Subject: AP1000 COL Response to Request for Additional Information (TR #44)

In support of Combined License application pre-application activities, Westinghouse is submitting a response to the NRC request for additional information (RAI) on AP1000 Standard Combined License Technical Report 44, APP-GW-GLR-026, Rev. 0, New Fuel Storage Rack Structural/Seismic Analysis. This RAI response is submitted as part of the NuStart Bellefonte COL Project (NRC Project Number 740). The information included in the responses is generic and is expected to apply to all COL applications referencing the AP1000 Design Certification.

RAI Response Number: RAI-TR44-11

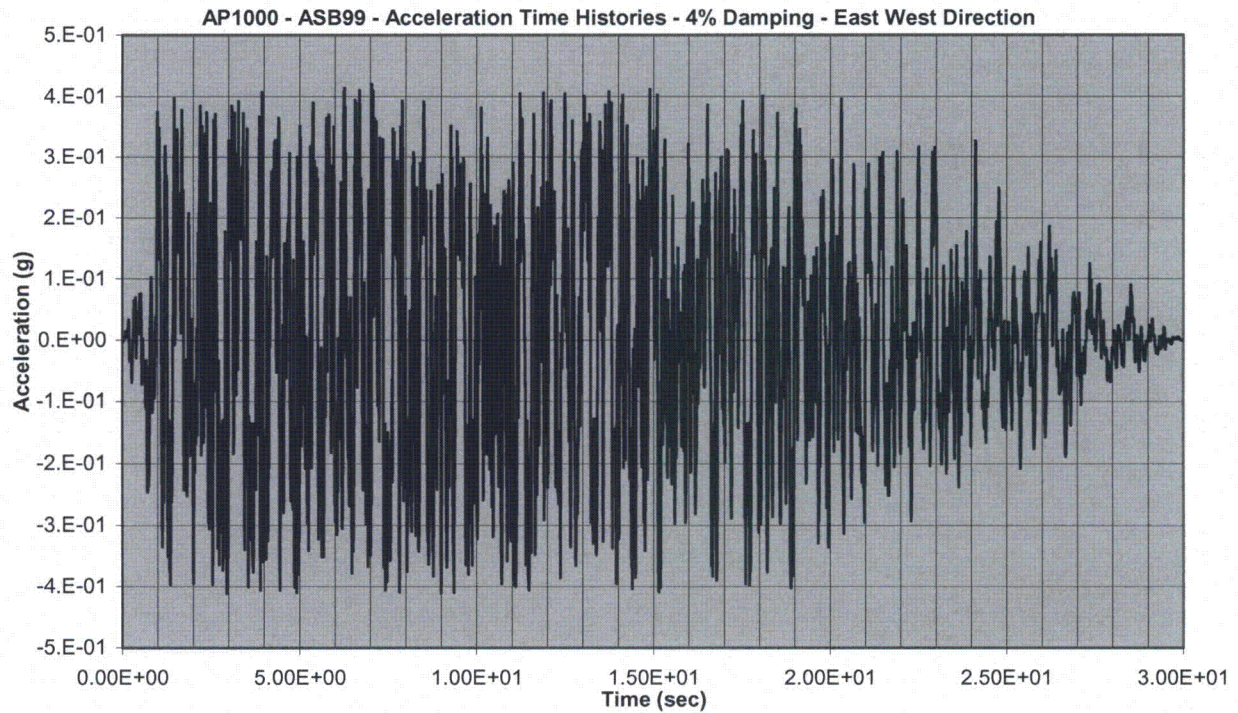
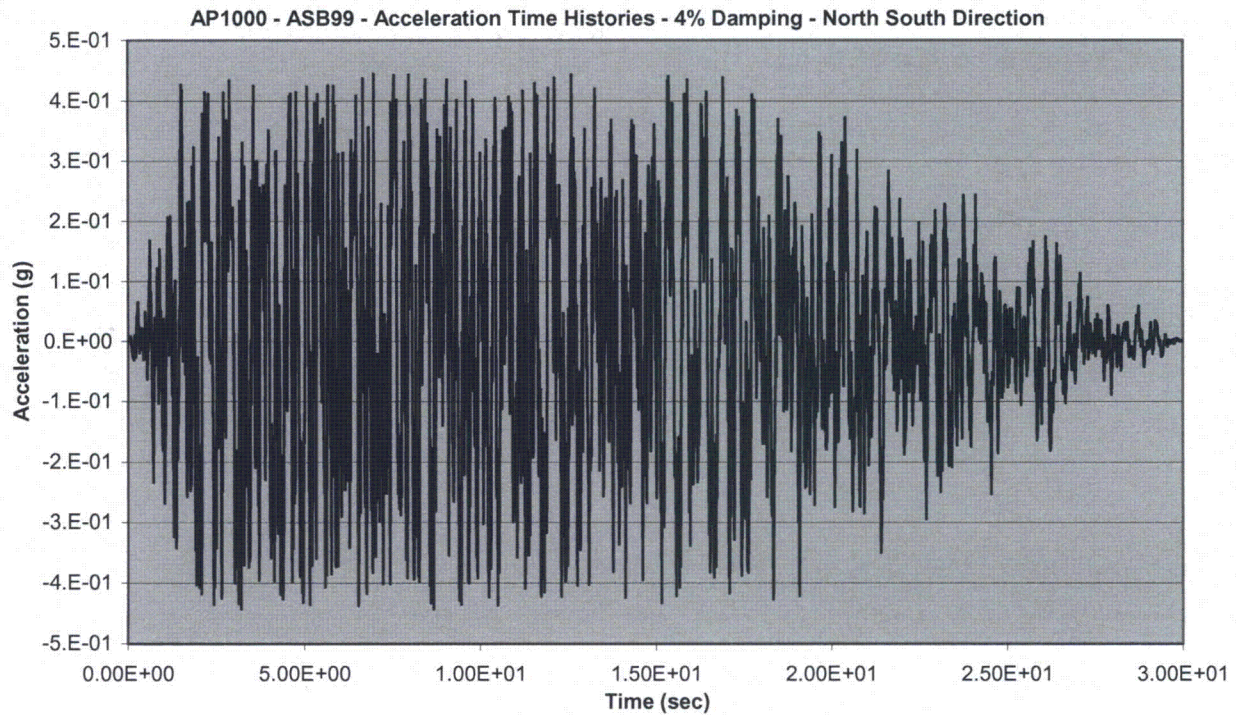
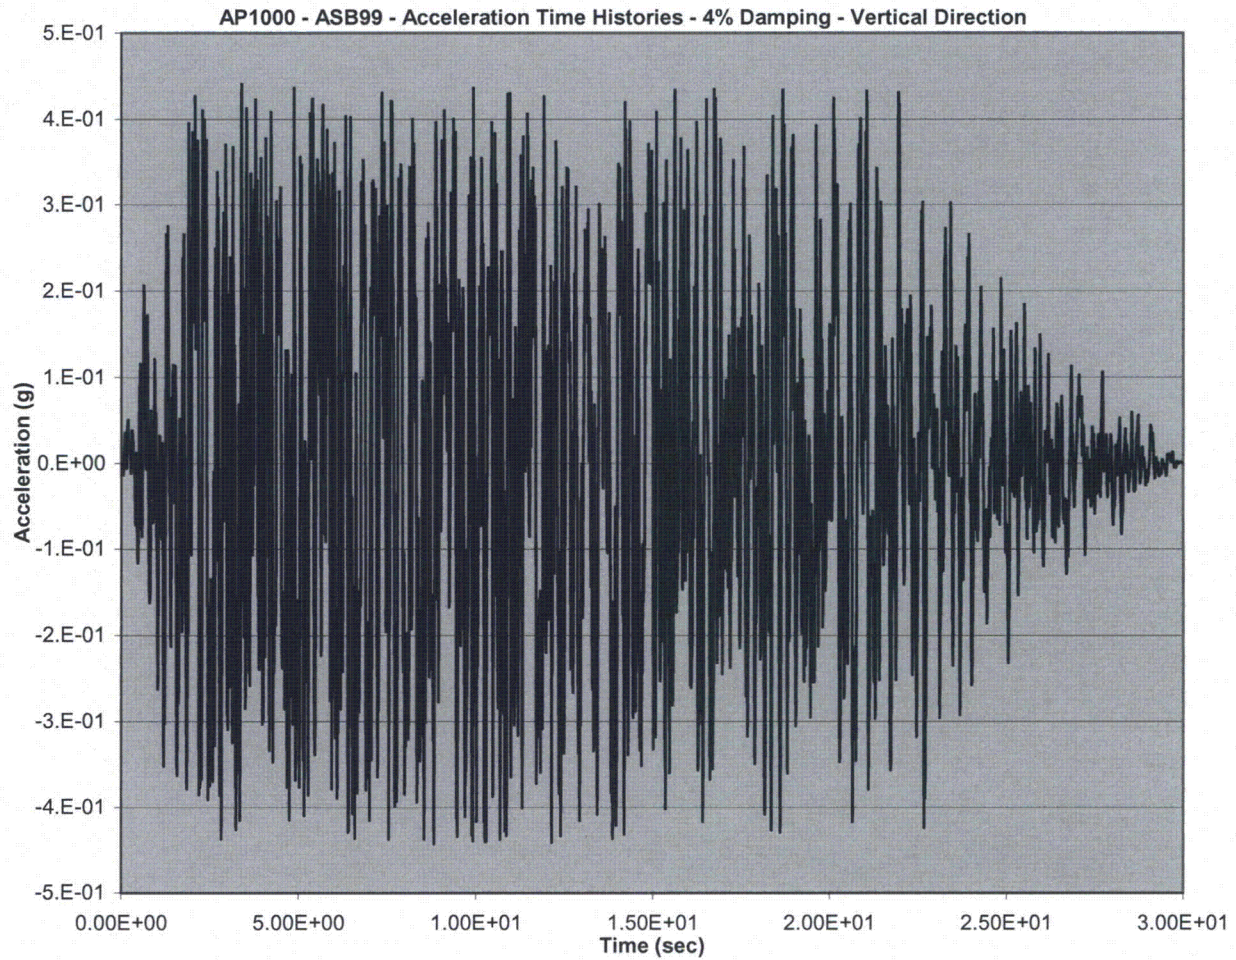
- (d) For the synthetic time histories, provide plots of the three time histories, the cross correlation coefficients, the comparisons of the spectra from the synthetic time histories to the enveloped target response spectra, and the comparisons of the power spectral density plots to the target power spectral density function associated with the target response spectra.

- d) The synthetic time histories, the response spectrum curves, and the power spectral density plots for the Auxiliary and Shielding Building (ASB) at Elevation 99 feet are provided in Figures TR44-11.1 through TR44-11.9. The cross correlation coefficients for the three orthogonal components (East-West, North-South, and Vertical) of the ASB99 synthetic time histories are summarized in the table below.
